THREE MILE ISLAND NUCLEAR STATION
UNIT 1

**GENERAL INFORMATION
ON THE EFFECTS OF
FLUID FLOW INSTABILITY IN
THE MAIN AND EMERGENCY
FEEDWATER SYSTEMS
OF THREE MILE ISLAND
NUCLEAR STATION UNIT 1**

GAI REPORT NO. 1881

This report presents the results of a design review and evaluation performed in response to the United States Nuclear Regulatory Commission (NRC) request, "General Information Required for Consideration of the Effects of Secondary System Fluid Flow Instability," dated May 15, 1975, for Three Mile Island Nuclear Station, Unit 1 (TMI-1).

FIGURE 3-1
 MAIN AND EMERGENCY FEEDWATER ISOLATION VALVES
 STEAM GENERATOR LA TO ANGRIC-1 FAST CONTAINMENT
 ISOLATION VALVES

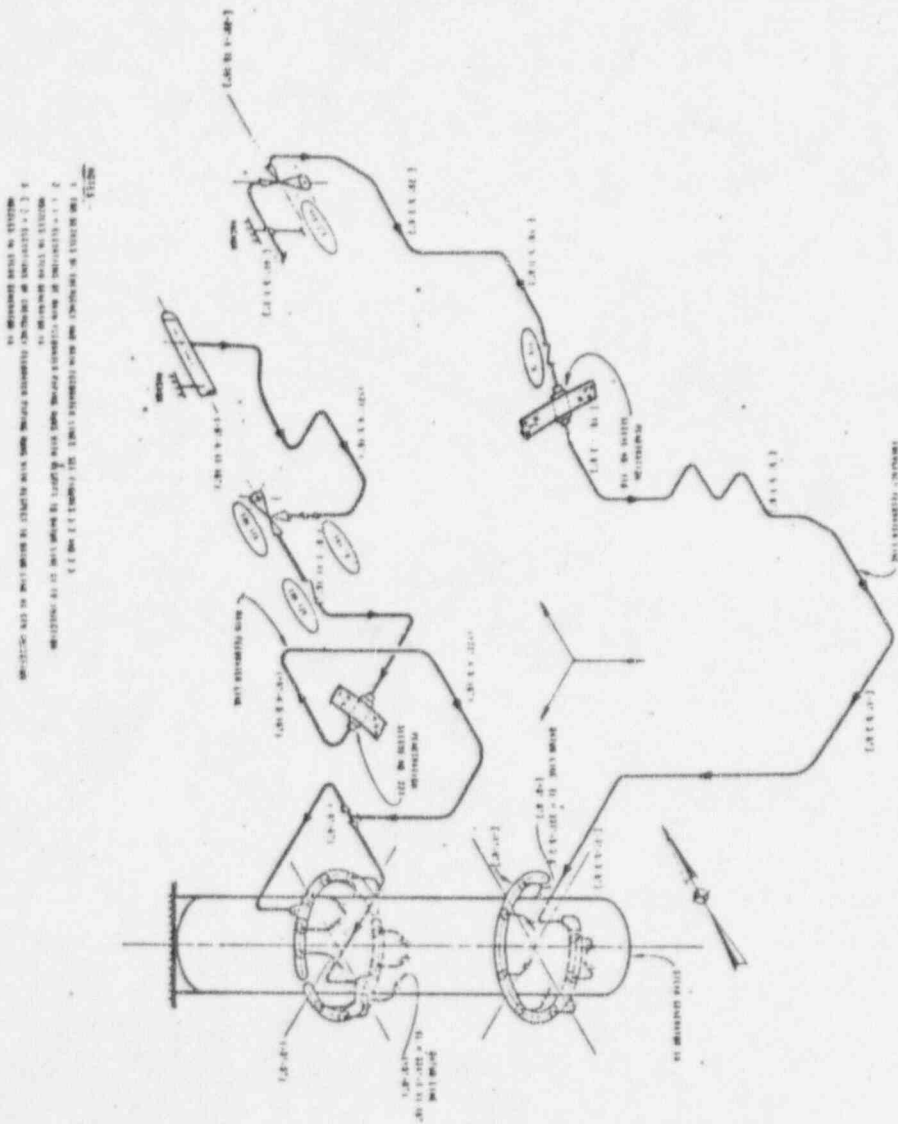
Describe and show by isometric diagrams, the routing of the main and auxiliary feedwater piping from the steam generators outwards through containment up to the outer containment isolation valve and restraint. Note all valves and provide the elevations of the sparger and/or inlet nozzles and all piping runs needed to perform an independent analysis of drainage characteristics.

Figure 3-1 is an isometric representation of those portions of the main feedwater (FW) and emergency feedwater (EFW) systems associated with steam generator 1A. These systems are completely separated from each other. All valves are noted and the height above (+) or below (-) the datum lines for the different parts of the piping runs are indicated. The datum lines are the elevations of the injection nozzles which are as follows:

The information provided by Figure 3-1 is sufficient to perform an independent analysis of the drainage characteristics of the entire feedwater system associated with steam generator 1A. This isometric diagram depicts the piping runs for each system (FW and EFW) from the steam generator inlet nozzles to the pipe anchor past the containment isolation valves outside the reactor building.
